**SOLICITATION AMENDMENT  
MODIFICATION DE L'INVITATION**

<b>Title - Sujet</b> Bâtiment d'entretien de l'équipemen	
<b>Solicitation No. - N° de l'invitation</b> EZ899-181343/A	<b>Amendment No. - N° modif.</b> 003
<b>Client Reference No. - N° de référence du client</b>	<b>Date</b> 2017-11-21
<b>GETS Reference No. - N° de référence de SEAG</b> PW-\$PWY-022-8224	
<b>File No. - N° de dossier</b> PWY-7-40239 (022)	<b>CCC No./N° CCC - FMS No./N° VME</b>
<b>Solicitation Closes - L'invitation prend fin</b> <b>at - à 02:00 PM</b> <b>on - le 2017-11-29</b>	<b>Time Zone</b> <b>Fuseau horaire</b> Pacific Standard Time PST
<b>F.O.B. - F.A.B.</b> <b>Plant-Usine:</b> <input type="checkbox"/> <b>Destination:</b> <input checked="" type="checkbox"/> <b>Other-Autre:</b> <input type="checkbox"/>	
<b>Address Enquiries to: - Adresser toutes questions à:</b> Arthur (PWY), Carolyn	<b>Buyer Id - Id de l'acheteur</b> pwy022
<b>Telephone No. - N° de téléphone</b> (604) 364-2752 ( )	<b>FAX No. - N° de FAX</b> (604) 775-6633

This amendment 003 is raised to:

PROJECT: PORT HARDY AIRPORT EQUIPMENT  
MAINTENANCE BUILDING

DRAWING NO:  
**AE-01 - ESK-01**

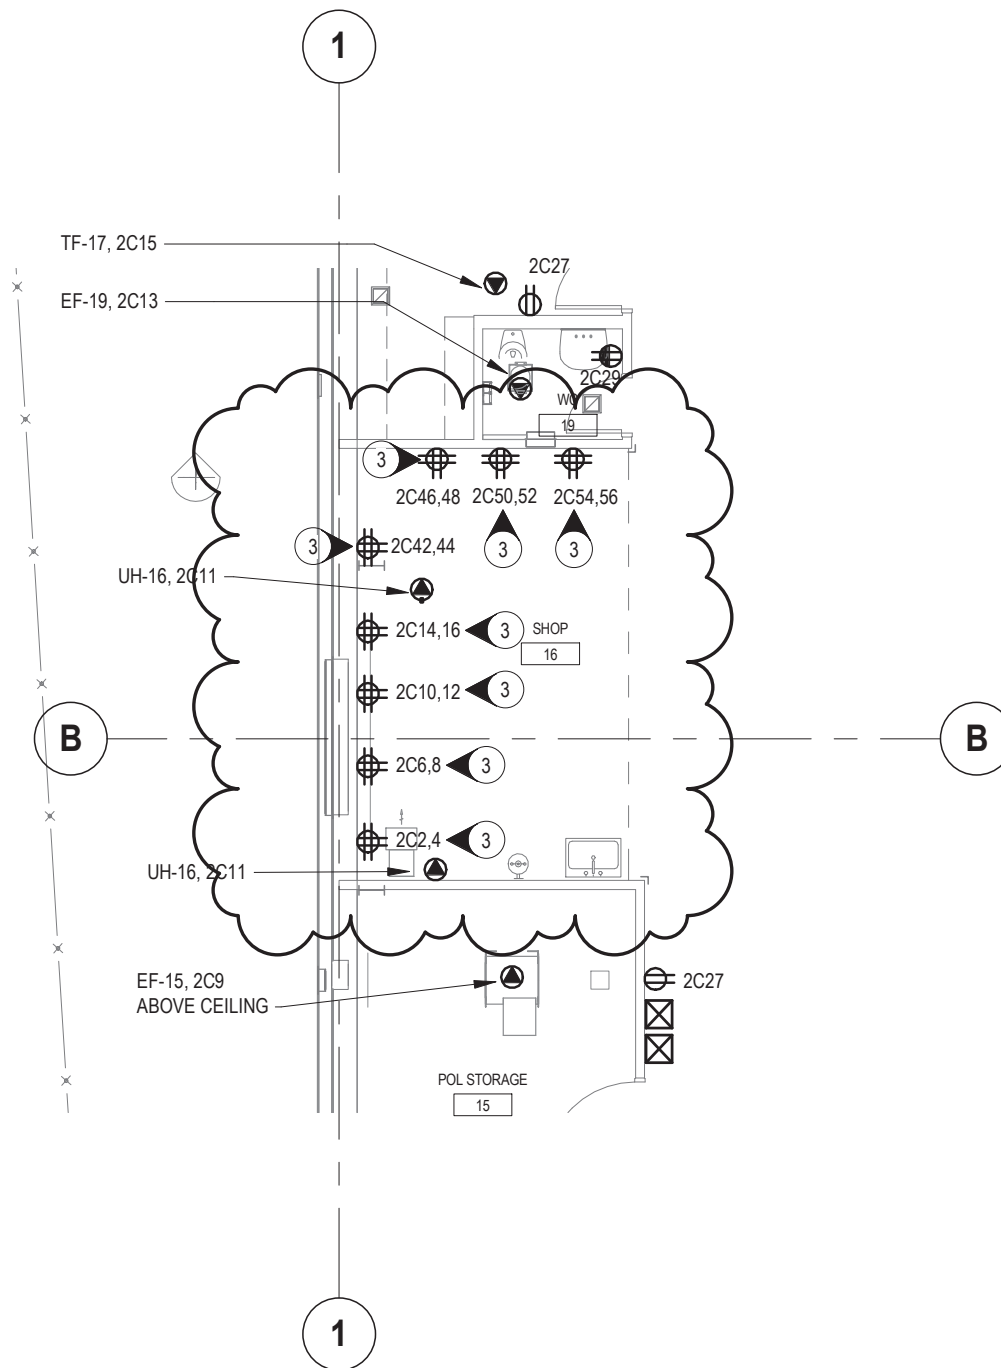
- .1                    Communications conduit to terminate into an in-ground pull box. Refer to attached electrical sketch ESK-01.
- .2                    Cut sections refer to details on this drawing (E-001) and not E-100.

DRAWING NO:  
**AE-01 - ESK-02**

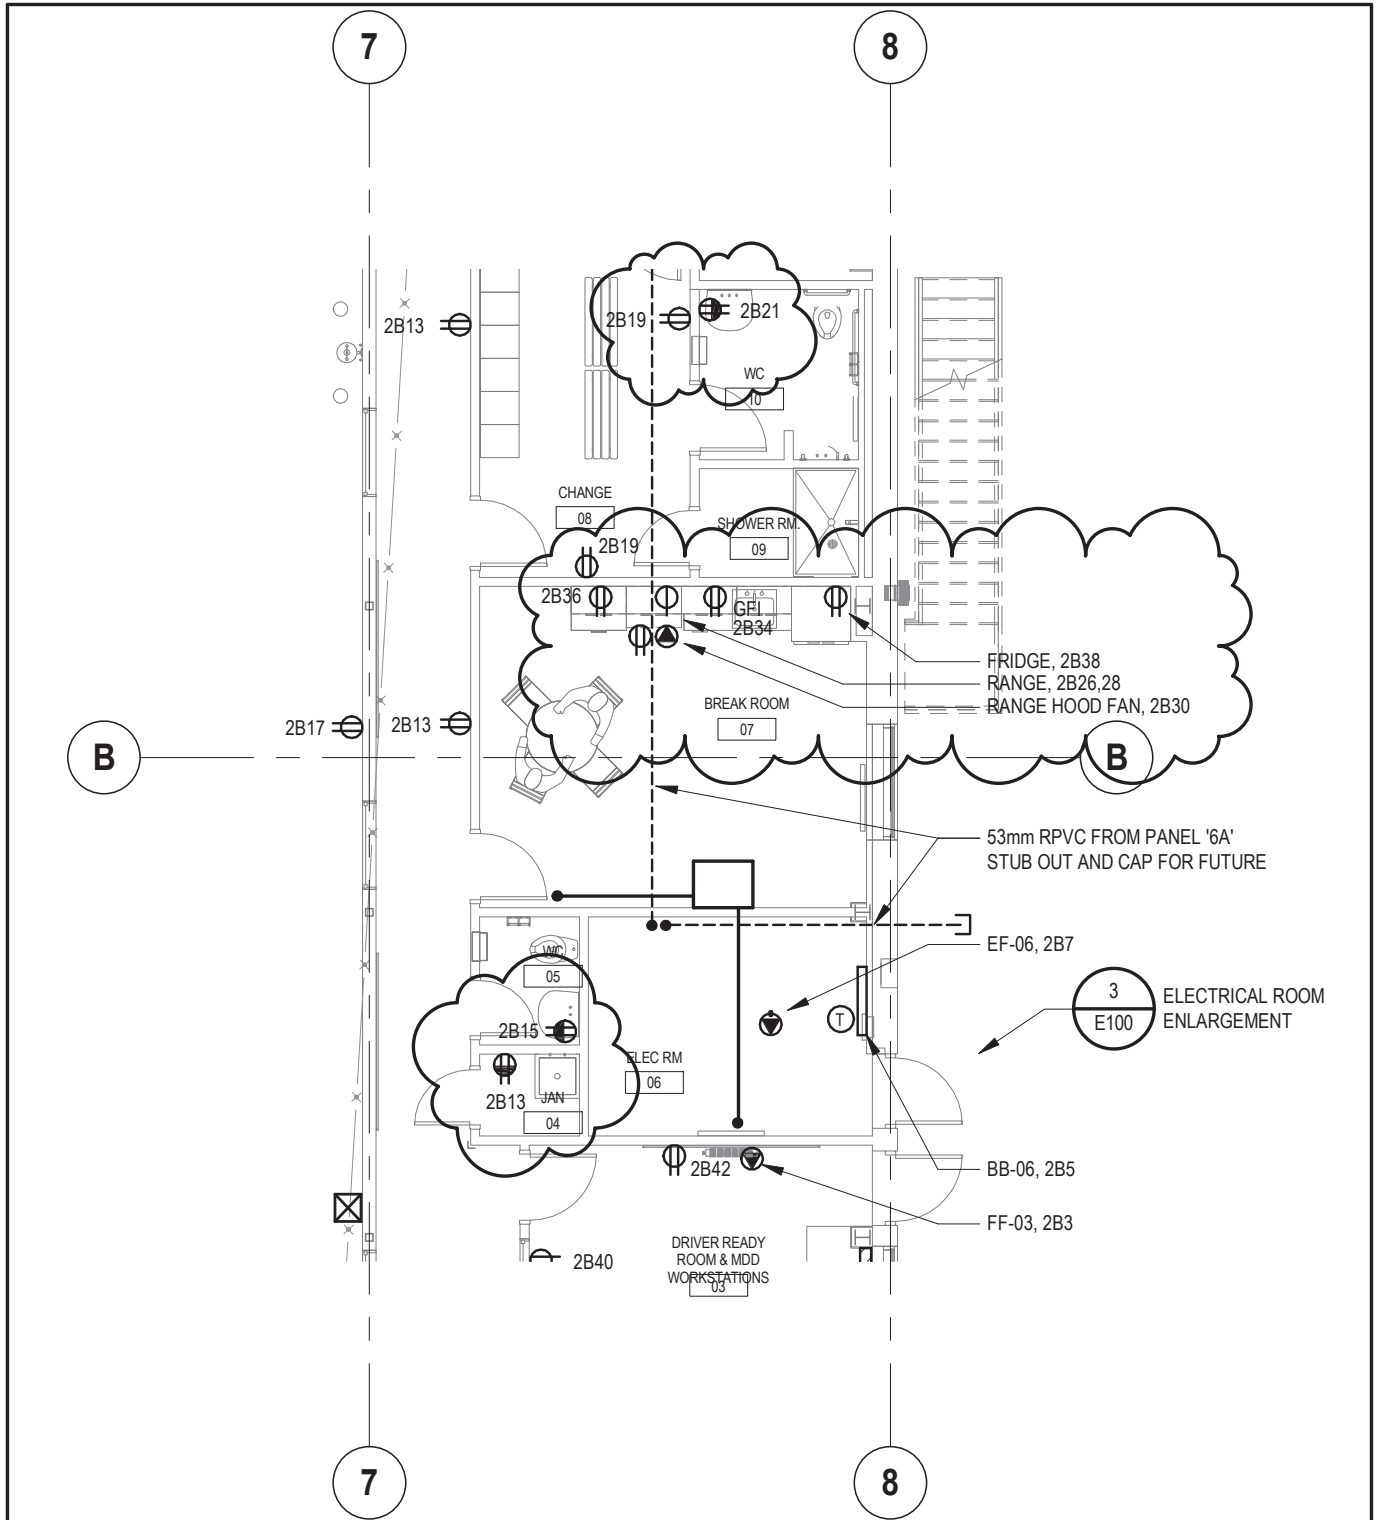
- .2                    Shop 16, all receptacles have been revised to four-plex receptacles c/w a dedicated circuit on each duplex (2 per 4-plex). Refer to attached electrical sketch ESK-02.

DRAWING NO:  
**AE-01 - ESK-05**

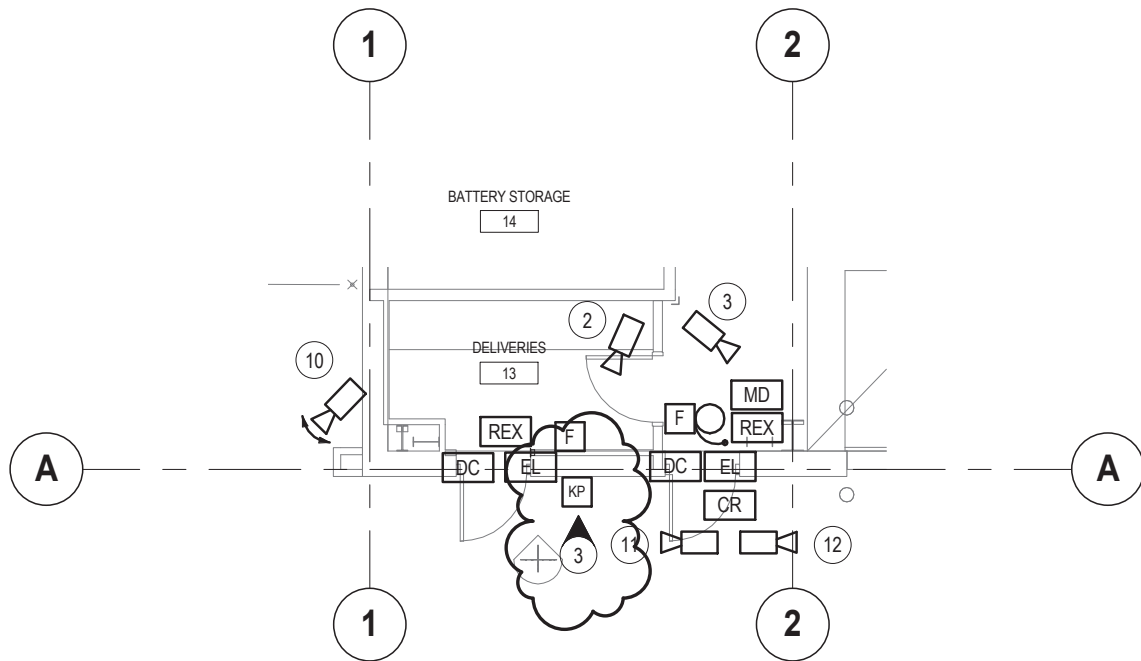
- .2 Delivery room security access keypad / card reader combo (KP), refer to keynote #3 for clarification, electrical sketch ESK-05.
- .3 Security cameras at main entrance on level 1 revised, refer to electrical sketch ESK-06.

- 1 WALL MOUNTED INTERCOM STATION CONNECTED TO MAIN ENTRANCE INTERCOM STATION
- 2 WALL MOUNTED MAIN ENTRANCE DOOR RELEASE PUSHBUTTON.
- 3 SECURITY ACCESS KEYPAD - CARD READER COMBINATION DEVICE FOR SECURED ACCESS TO DELIVERY ROOM.

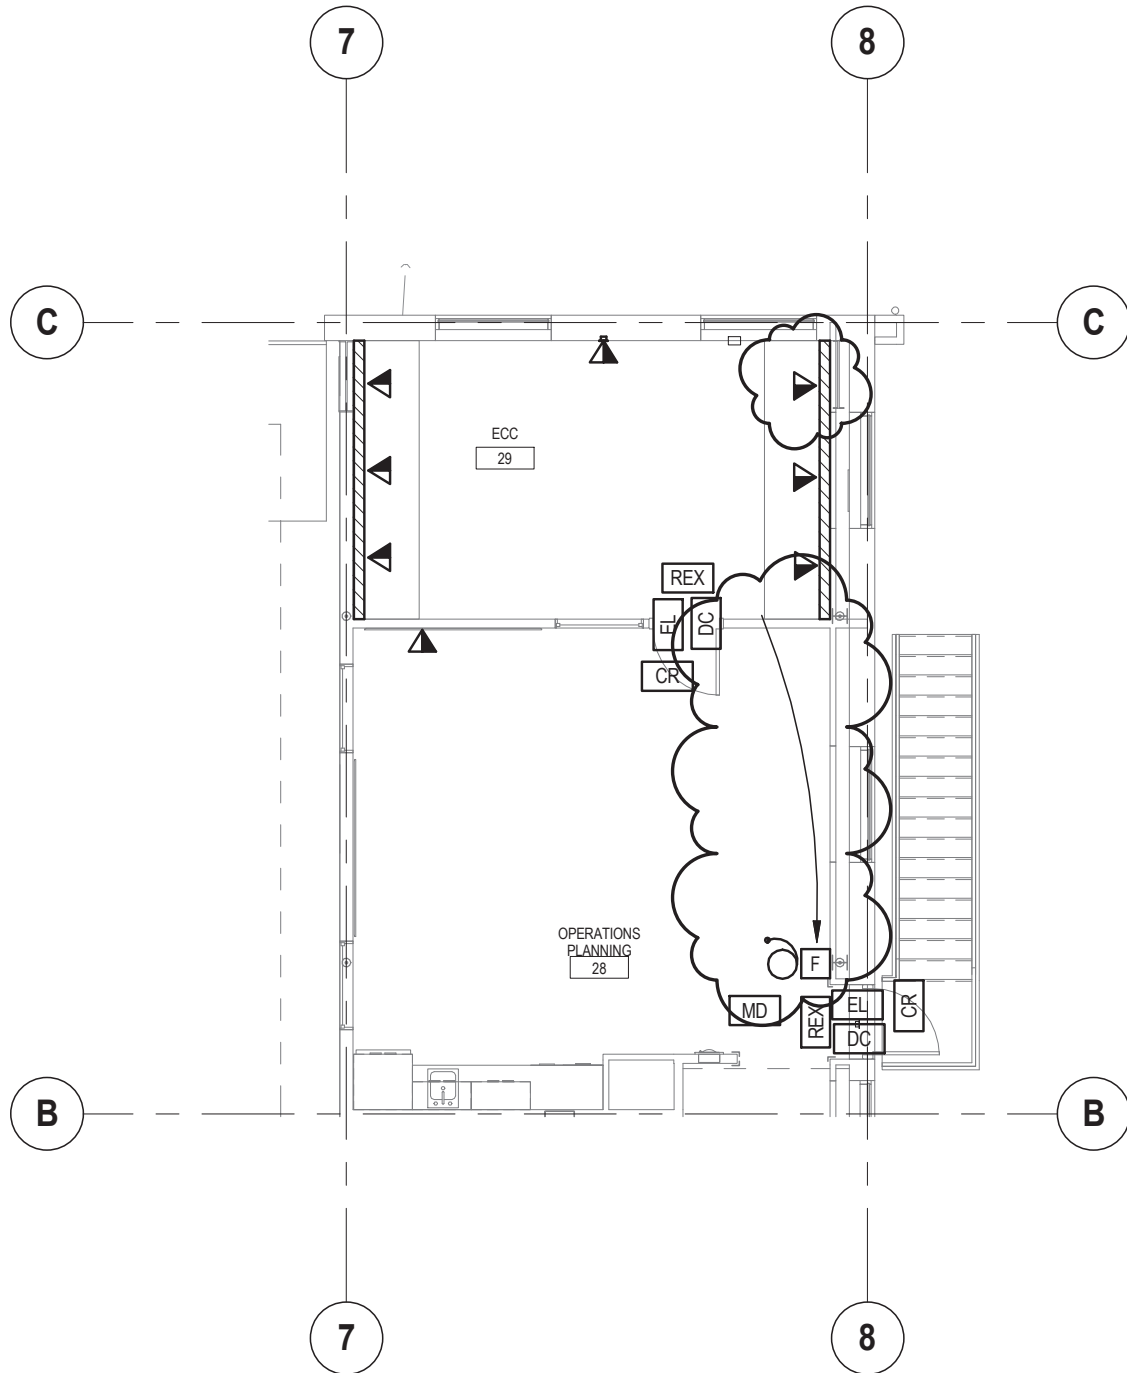
- .4 Add two tamper switches for double check valves to mechanical rooms, nomenclature for sprinkler Tamper switches revised to `TS' for consistency between disciplines, refer to electrical sketch ESK-06.

DRAWING NO:  
 AE-01 - ESK-07

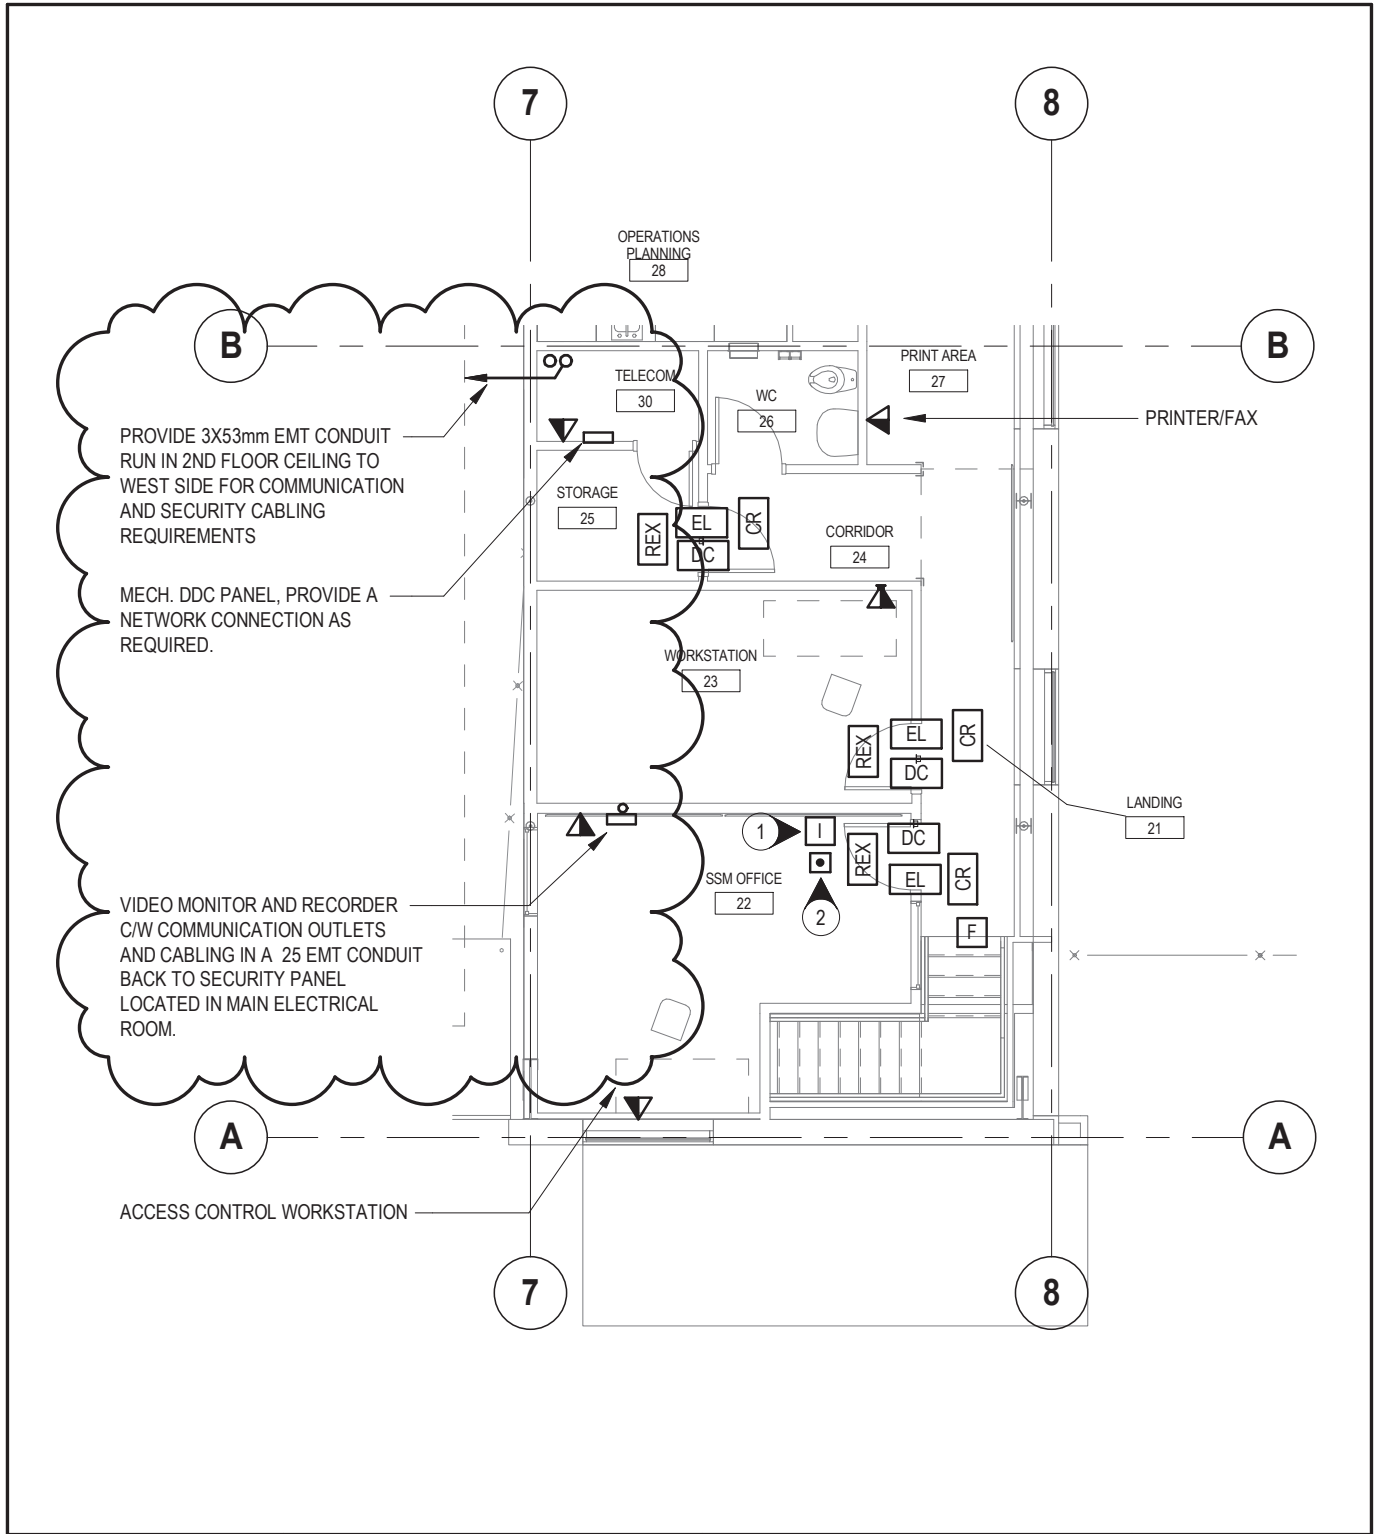
- .5 Fire alarm bell relocated from room ECC #29 to corridor east wall, refer to electrical sketch ESK-07.
- .6 Provide an additional communication outlet in ECC Rm #29, refer to electrical sketch ESK-07.

AE-01 - ESK-08

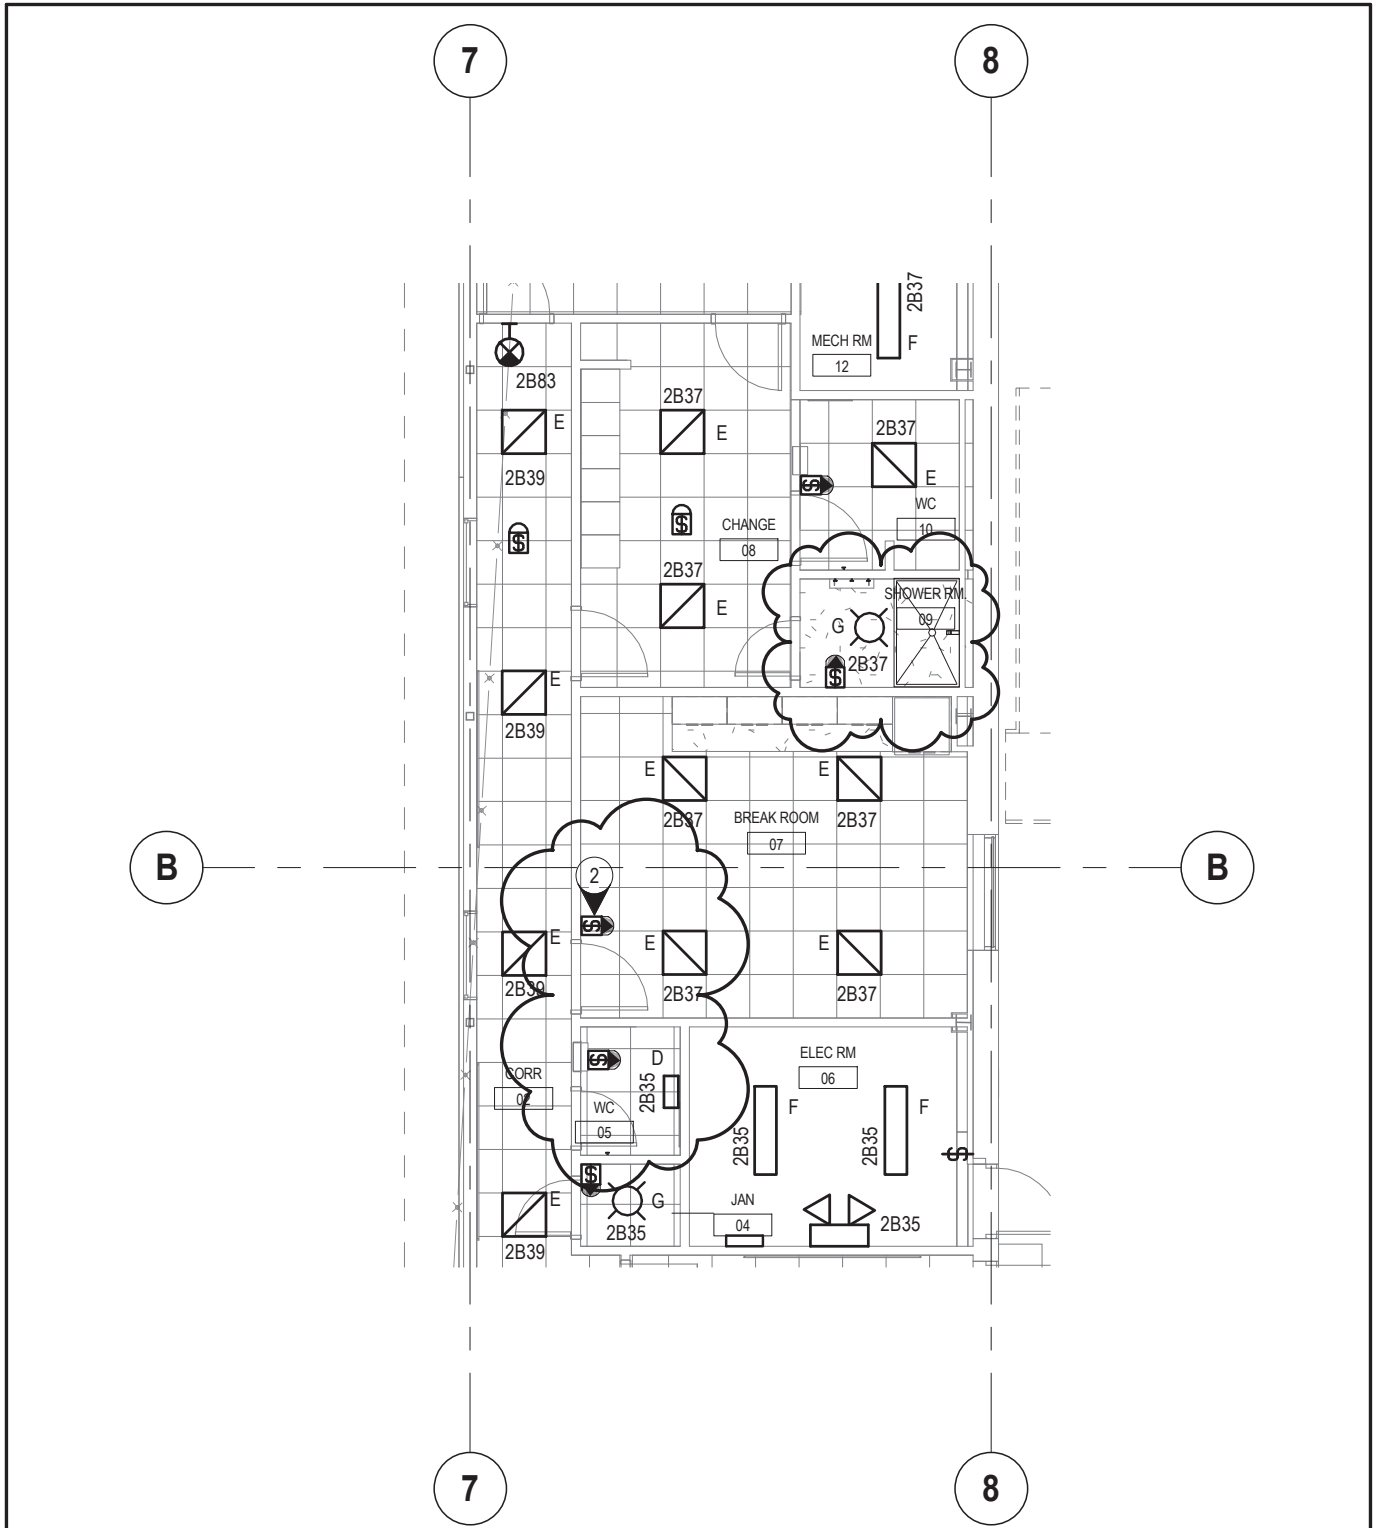
- .7 Provide a Mechanical DDC panel in the Telecom Rm c/w power and communication connections as shown, refer to electrical sketch ESK-09.
- .8 Refer to electrical sketch ESK-08 for clarification on communication cabling to main electrical room.
